**Town of Kittery
Planning Board Meeting
December 14, 2023**

ITEM 4—27 & 29 Wentworth—Major Site Plan — Final Review

**Re: Site Plan Review
Tax Map 9, Lots 37 & 38
27 & 29 Wentworth Street
P5431**

CONCRETE SIDEWALK NOT TO SCALE

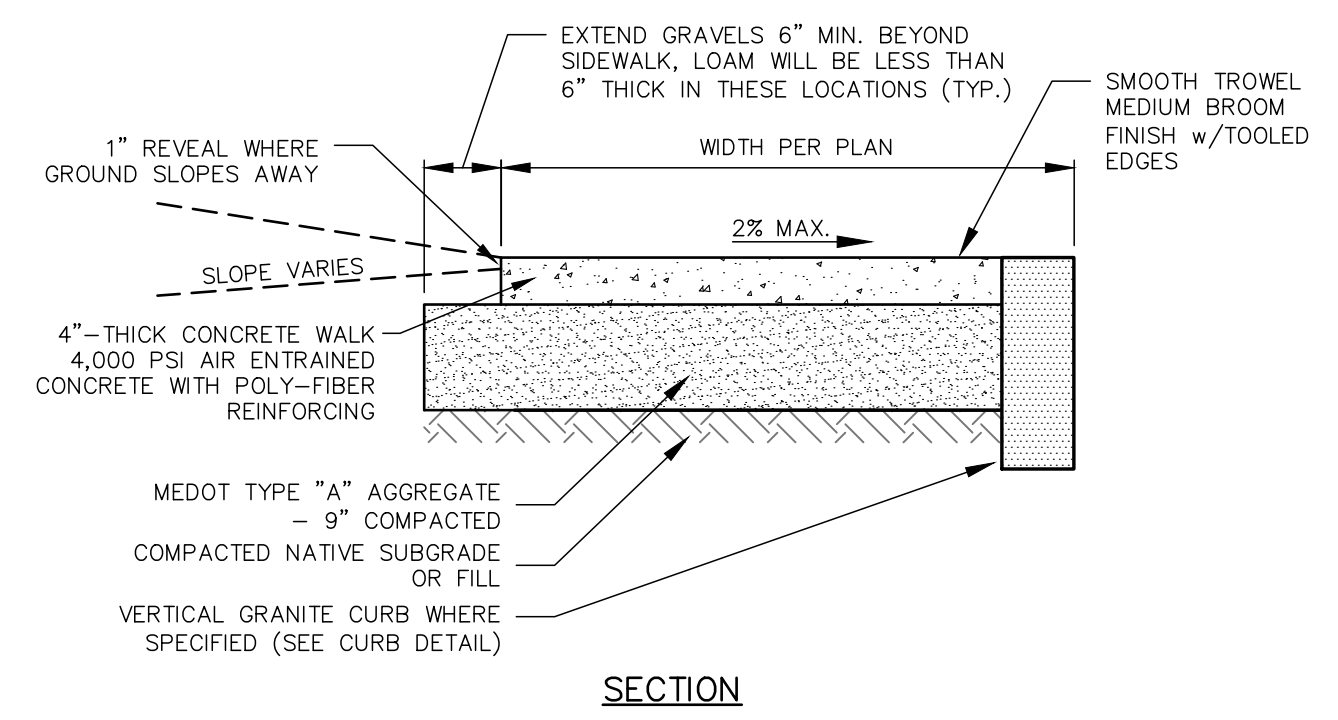
1. The Concrete Sidewalk detail references NHDOT specifications. This comment is unaddressed. **Altus: The reference to NHDOT has been corrected to reference MeDOT.**
2. Details should be provided for the signs. This comment is unaddressed. Please contact me directly if you have any questions or require any additional information. **Altus: The handicap accessible sign has been added to the plan set.**
